## **T10/06-470 revision 1**

From: George Penokie (IBM)

Subject: SAS-2: Transport layer read data flowchart

Figure 1 — Representation of transport layer (i.e., ST\_TTS1 and ST\_TTS3) read data operation

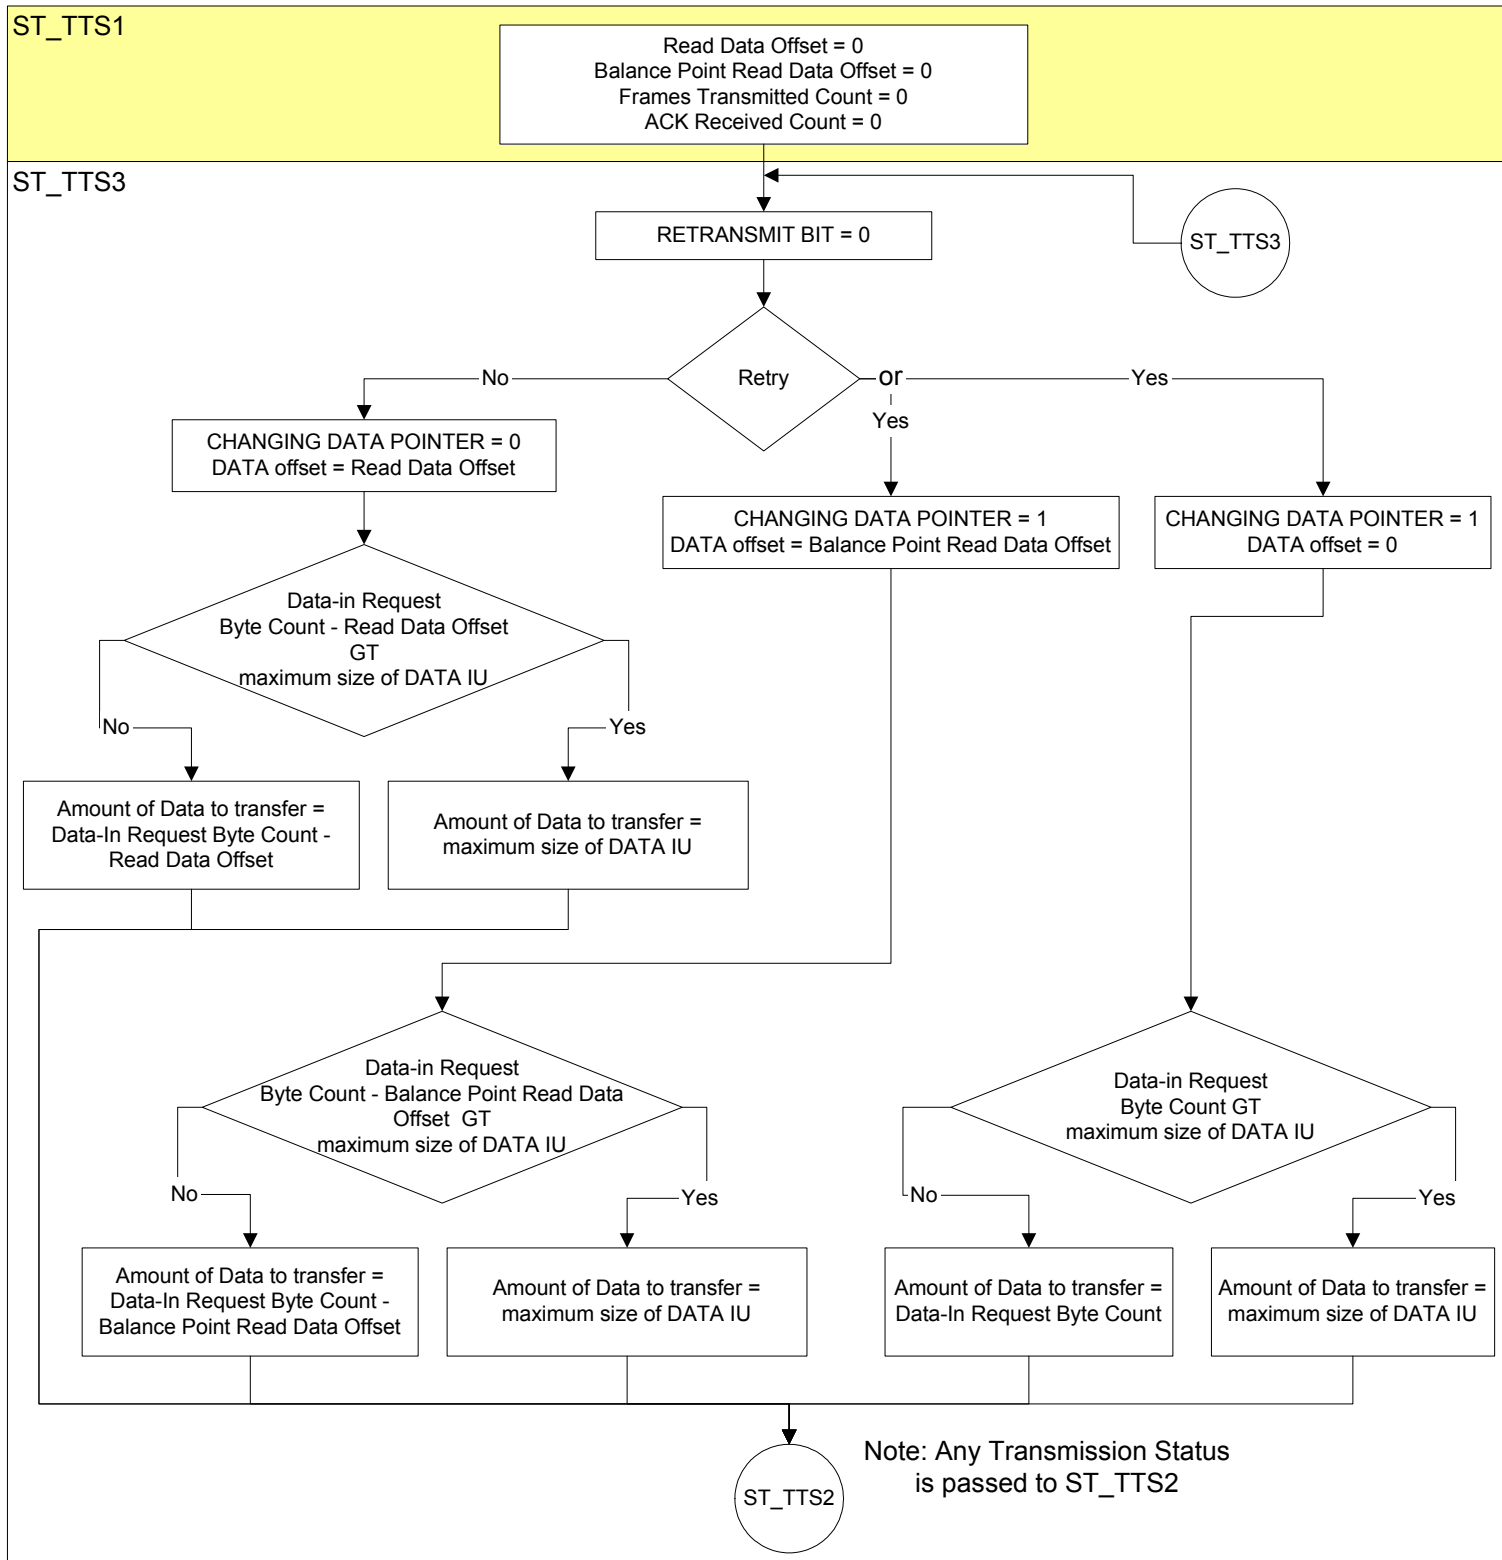
In the process of converting the words that are currently in SAS-2 there were no errors found, however, some of the wording may be somewhat unclear. Also, it was discovered that one of the conditions described in ST\_TTS3 can never happen and another is already checked in ST\_TTS2 so this proposal is recommending that they be deleted. See below the flowcharts for the suggested changes.
